ADEQUACY OF STATION ELECTRIC DISTRIBUTION SYSTEM
VOLTAGES, OCONEE NUCLEAR STATION, UNIT NOS. 1, 2
AND 3

This is an informal report intended for use as a preliminary or working document

Prepared for the
U.S. NUCLEAR REGULATORY COMMISSION
Under DOE Contract No. DE-AC07-76ID01570
FIN No. A6429

Figure 1. Oconee Electrical Single Line Diagram - Unit 1

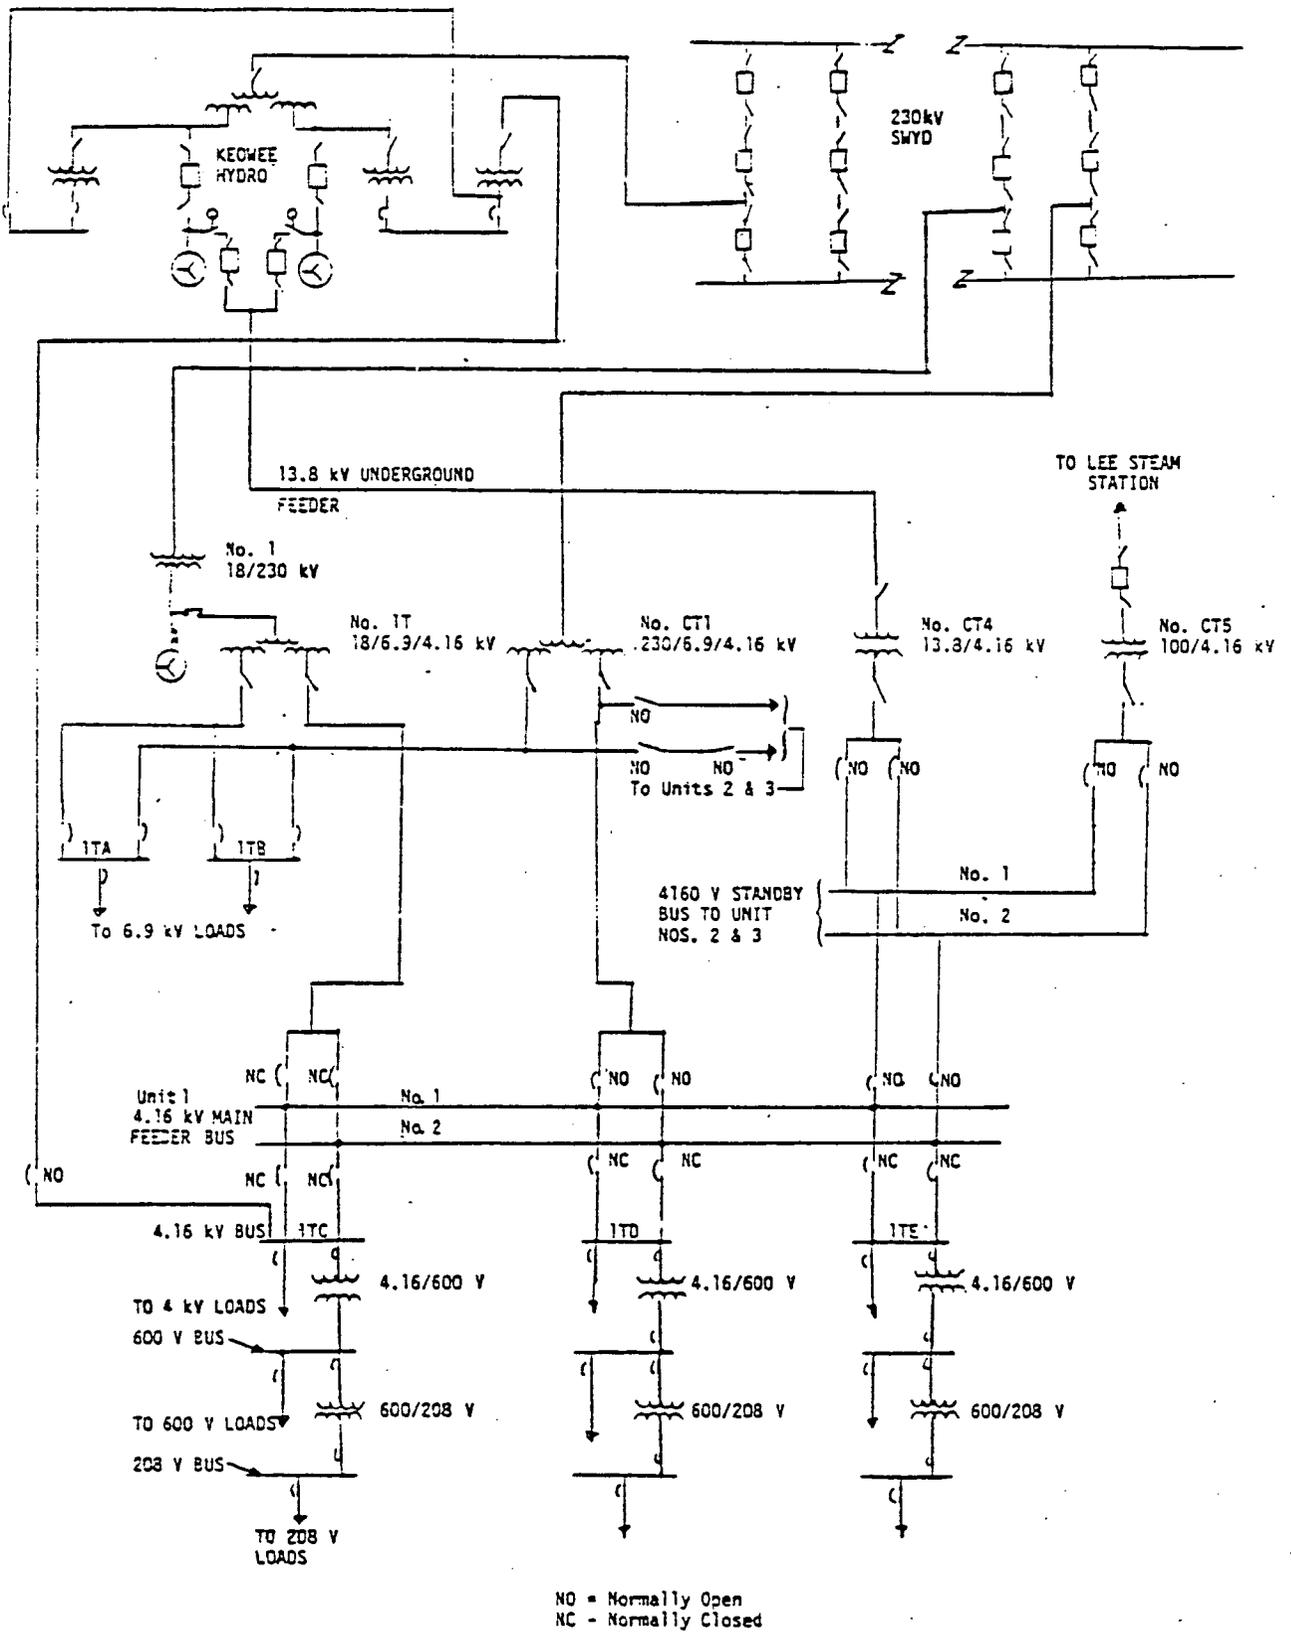
Figure 1 of this report is a simplified sketch of the Oconee electrical single-line diagram. The following description pertains to Unit 1. Unit Nos. 2 and 3 are similar.

During normal plant full-power operation, auxiliary power is supplied by the unit auxiliary transformer No. 1T and during startup and shutdown, by the startup transformer No. CT1 via the 230kV switchyard. Provisions are made for automatic fast transfer of the auxiliary loads from the unit auxiliary transformer to the startup transformer on a unit trip. A second

independent circuit is available from the 230kV switchyard (525kV switchyard for Unit No. 3) to the onsite distribution system via the main transformer and the unit auxiliary transformer for that unit when the main generator bus disconnect links have been removed. Complete loss of all offsite power will result in the automatic transfer to either of the two onsite Keowee hydroelectric generators which are capable of supplying all the emergency and shutdown loads via CT4. Emergency and shutdown loads can also be supplied from a gas turbine generator at the Lee Steam Station via CT5. This generator is isolated from the grid and is considered an onsite source.⁶

There are three essential 4.16kV buses; No. 1TC, 1TD, and 1TE. One division of safety-related equipment is powered from each of these buses. Each bus supplies 4kV loads, the 600V load centers and motor control centers (MCCs), and, in turn the 208V MCC's and the 125/250VDC systems.
